APPLICATION NO.	FILING DATE	FIRST NAMED INVENTOR	ATTORNEY DOCKET NO.	CONFIRMATION NO.
10/561,999	12/23/2005	Mary E. Fortuna	US030213	1348
24737 7590 08/06/2008 PHILIPS INTELLECTUAL PROPERTY & STANDARDS P.O. BOX 3001 BRIARCLIFF MANOR, NY 10510				
EXAMINER				
WILLIAMS, AARON				
ART UNIT		PAPER NUMBER		
2889				
MAIL DATE		DELIVERY MODE		
08/06/2008		PAPER

Office Action Summary

DETAILED ACTION

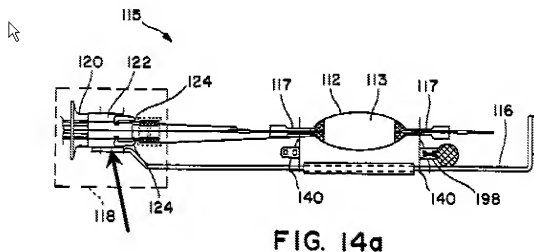
Regarding claim 5 Hassink discloses and Johanning teaches, **An electric lamp as claimed in claim 4**, Johanning further teaches **wherein the horizontal clip is attached at a second end to the a portion of the main frame**. Refer to the picture below and column 9 lines 10 - 15 and 43 – 45 where support clip (140) is described.

(143) Holds portion (130) of
frame (116)
(145) Holds portion (117) of arc
tube (112)
